May 3, 2019

**Subject: Comments on Tentative Order No. R1-2019-0006 for the City of Arcata
Wastewater Treatment Facility (Reissuance of NPDES No. CA0022713)**

Attachment 1 – Non-Substantive Comments on Tentative Order No. R1-2019-0006 for the City of Arcata Wastewater Treatment Facility

Figure No. 2.3
PROCESS FLOW DIAGRAM
 CITY OF ARCATA
 REVISED APRIL 2019

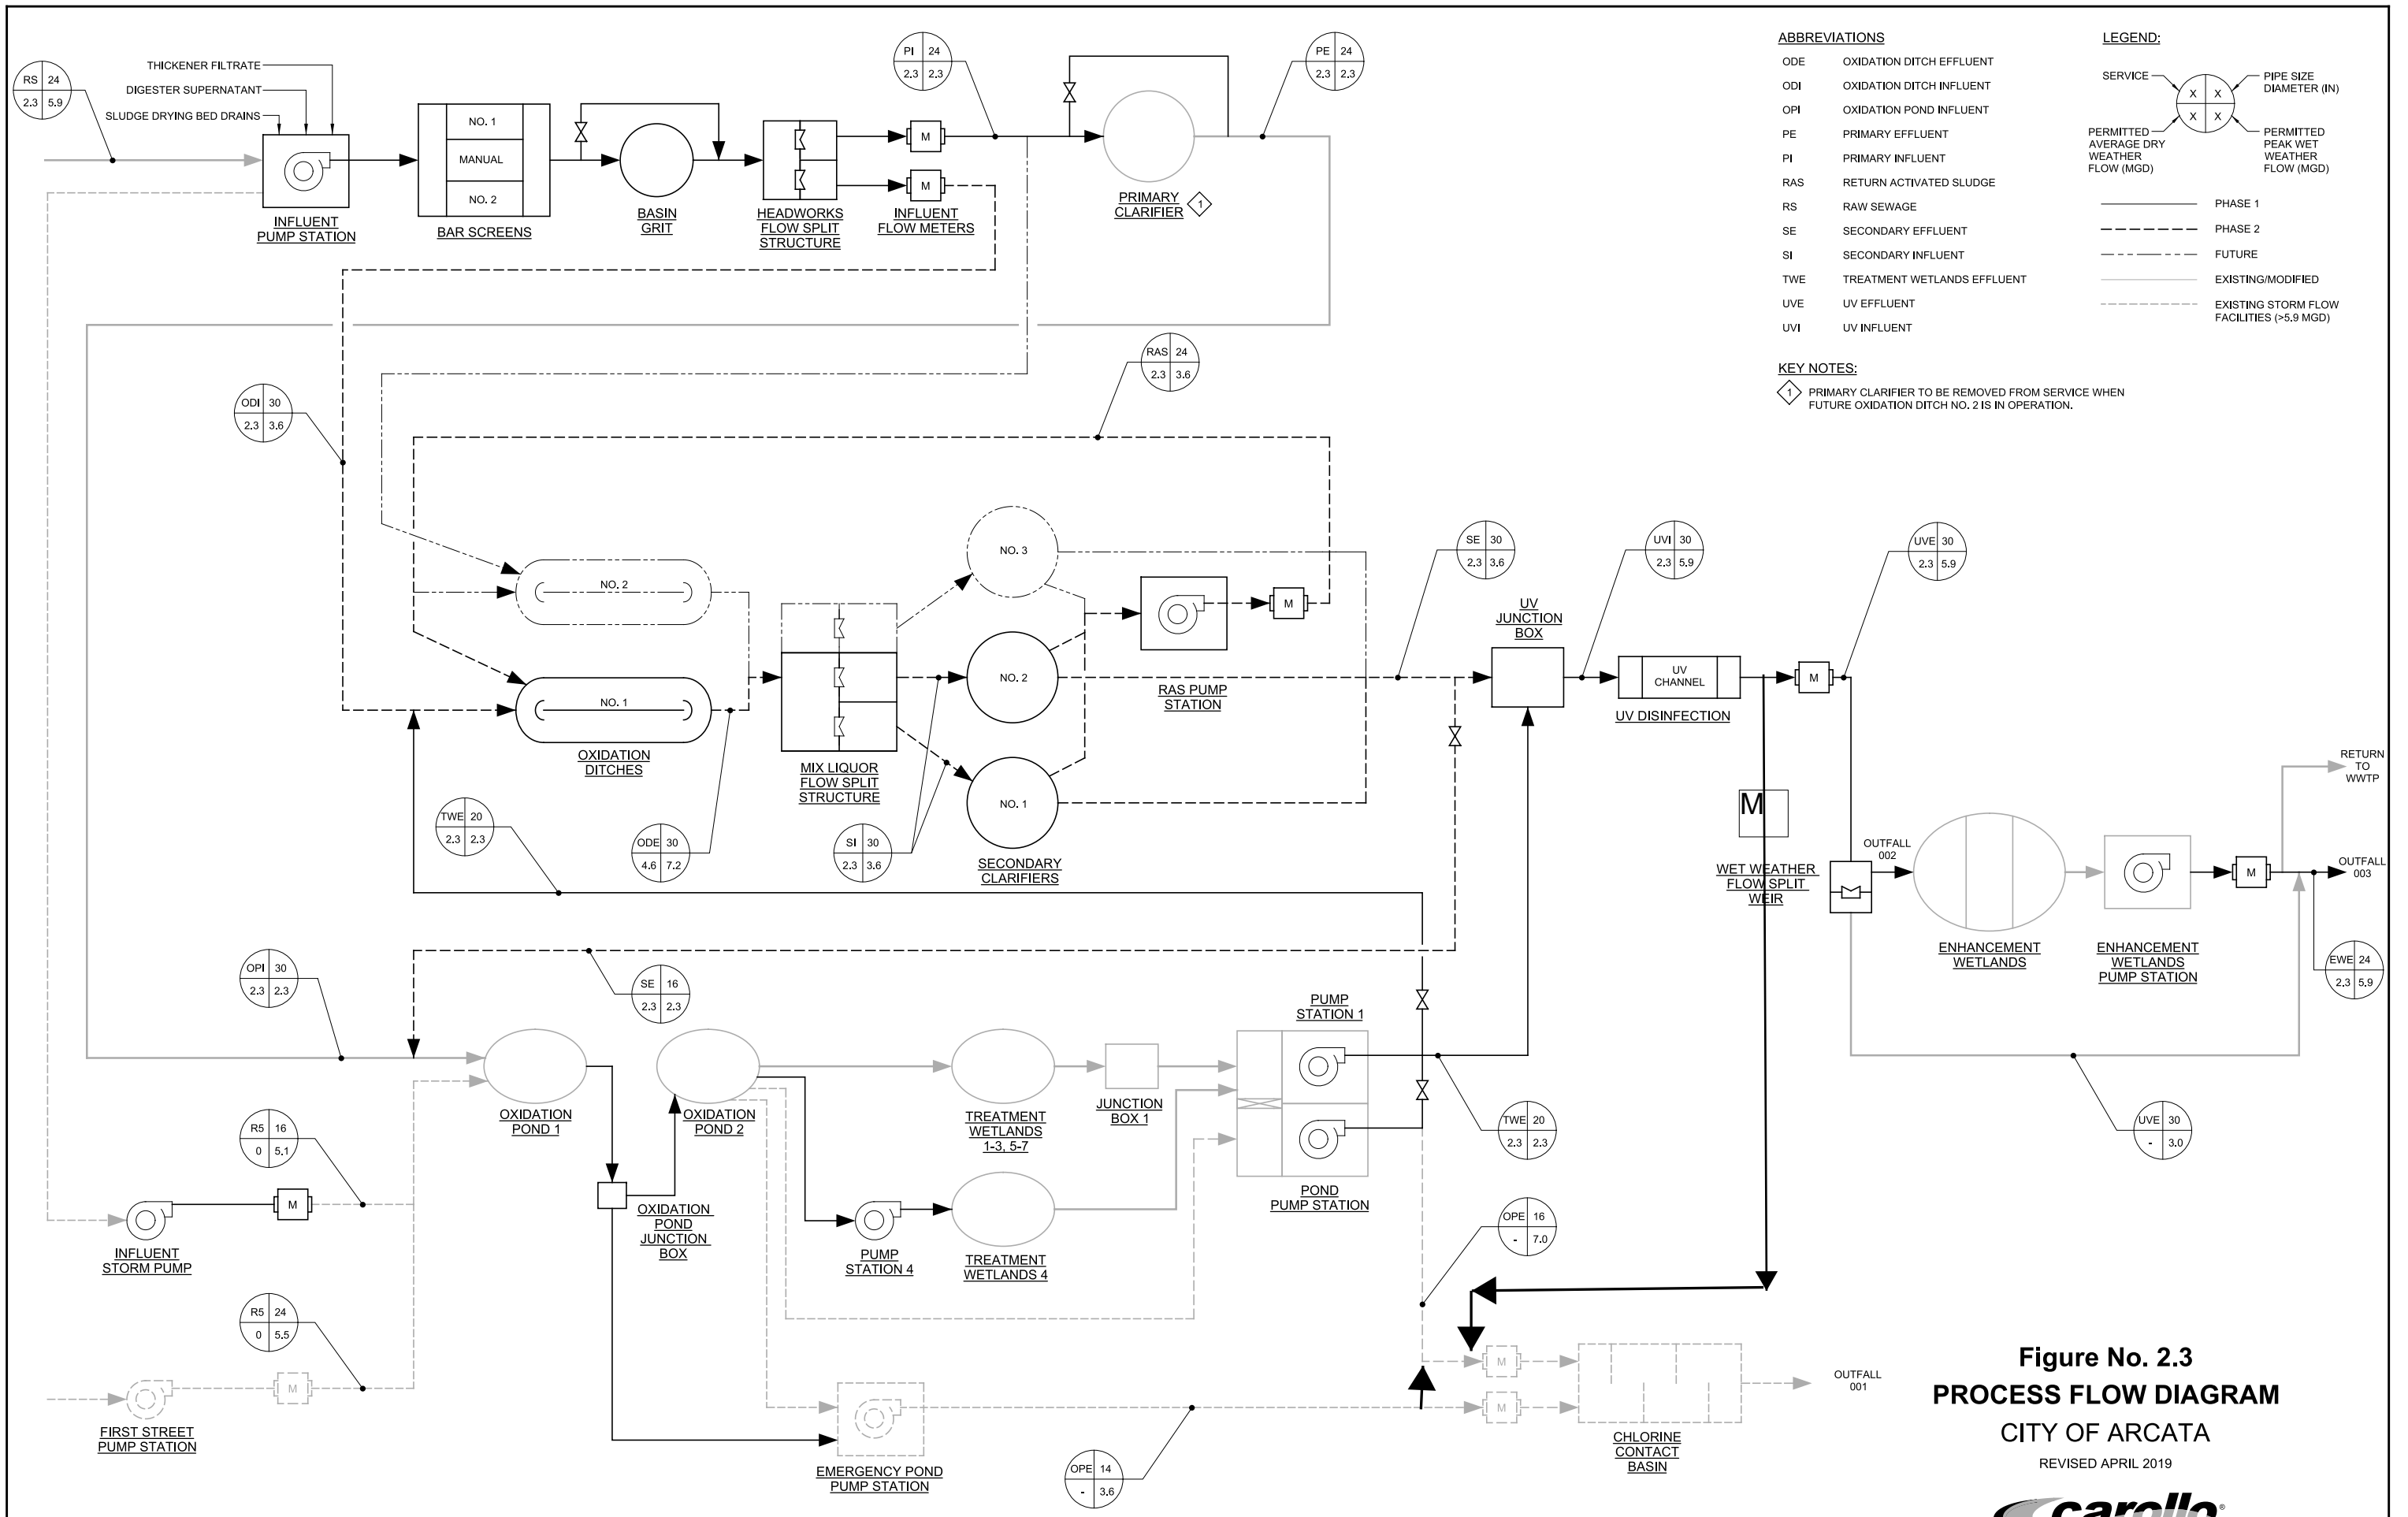
15. The process flow schematic for the Upgrade Project has been modified. The new schematic shows the "Adaptive Management Diversion Line (A-Line)" as described in the 9/21/18 letter to Justin McSmith. Revised Attachment C-2 is provided with these comments.
